BOARD OF COUNTY COMMISSIONERS CITRUS COUNTY

Please find enclosed our response to the list of deficiencies as noted in your interoffice memorandum to Clabe August 18, 1988, as well copy of as aforementioned memorandum.

Permit Modification for Closure

Citrus County Landfill

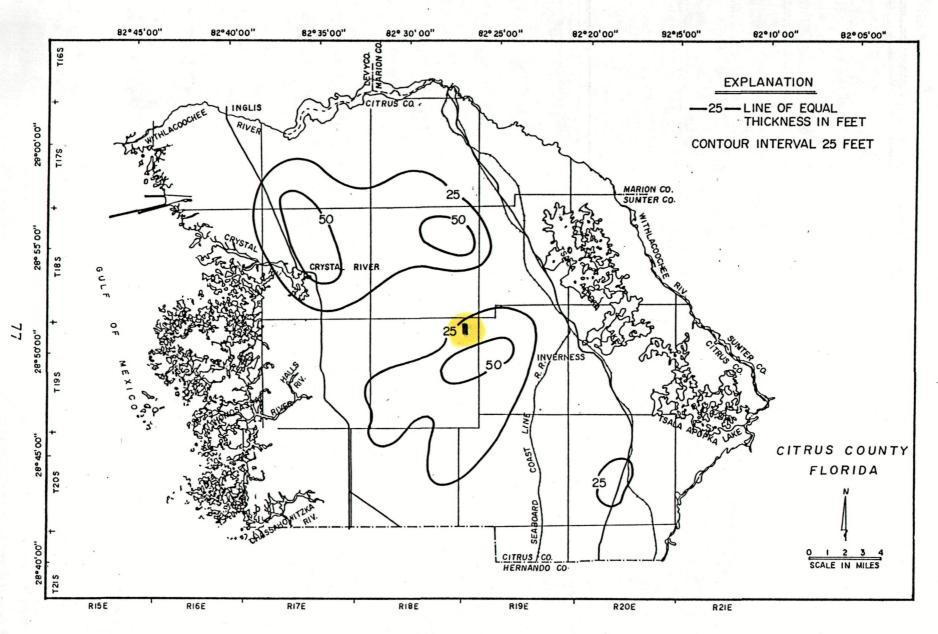
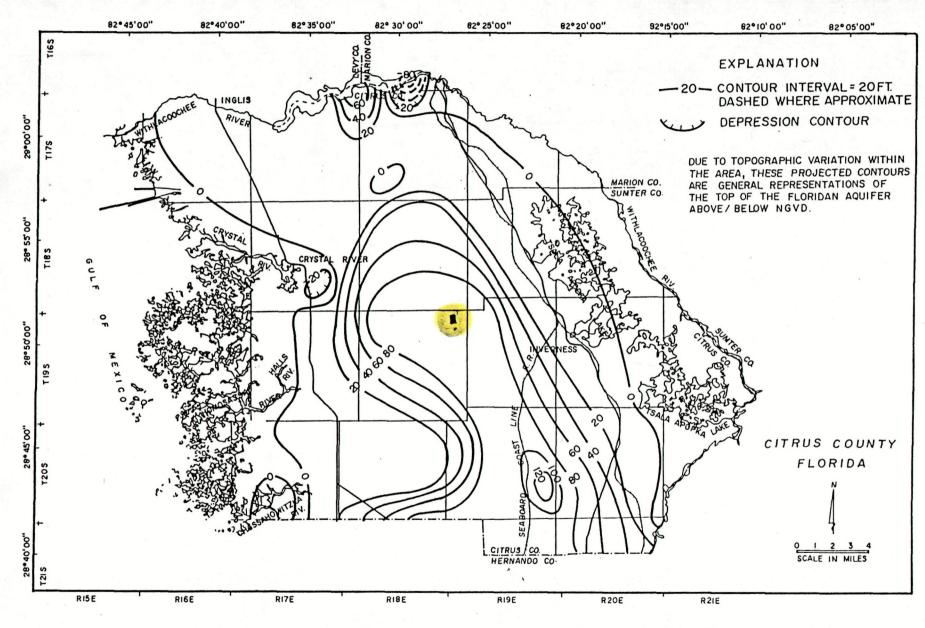
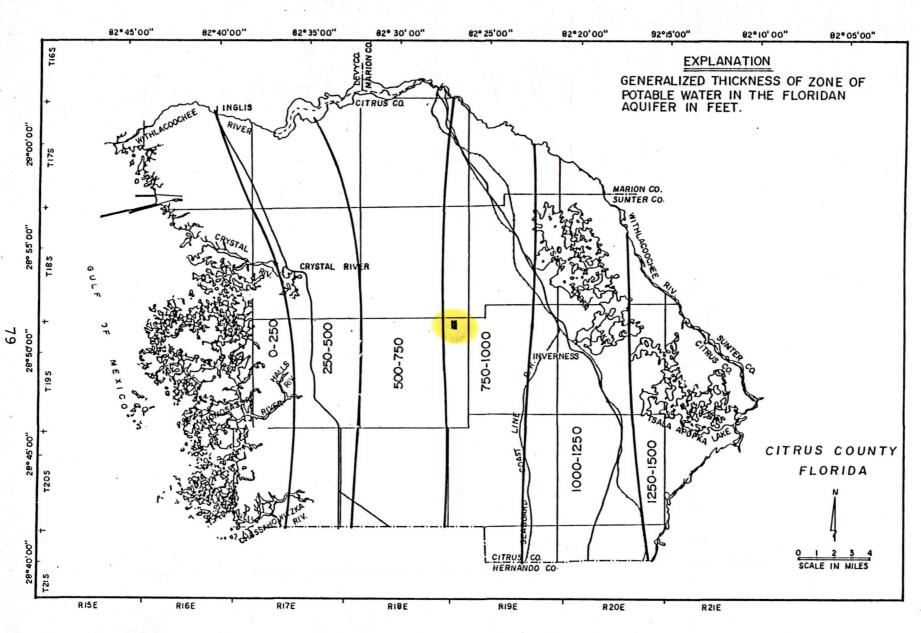
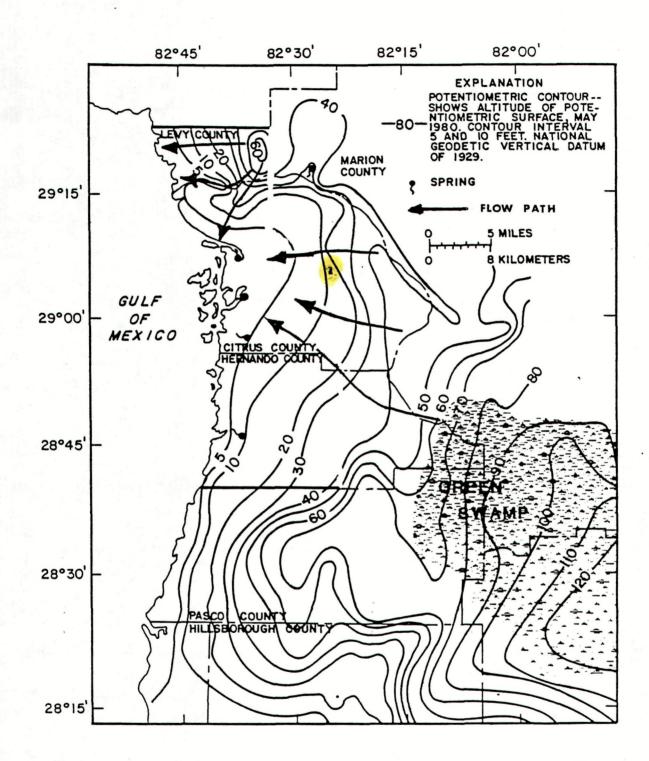
- Lease/ownership agreement shall be submitted and shall verify conformance with Rules 17-7.070 through 17-7.076, F.A.C., for long-term care, right of entry, and groundwater monitoring.
- Area Information Report shall be submitted.
- 3. Gas Migration Investigation to be conducted ASAP, and results submitted.
- 4. Groundwater assessment is needed based upon more recent data.
- 5. Closure Schedule of four years is unacceptable and shall be revised.

Attachment (D) is hydrolgeologic information copied from the Groundwater Resource Availability Inventory for Citrus County supplied by Southwest Florida Water Management District. The area in question is highlighted on each of the four copies. Included are thickness of the upper confining unit, depth to top of the Floridan aquifer, potable water zone thickness, and flow direction of the Floridan

aquifer.

The groundwater table has been recorded at approximately 120 feet below ground elevation at the landfill site. This is representative of the area with topographic variations resulting in some changes. The groundwater typically flows from east to west. There is no recharge/discharge areas within one mile of the landfill site. There are numerous private wells north of the landfill and no public wells within the one mile radius.
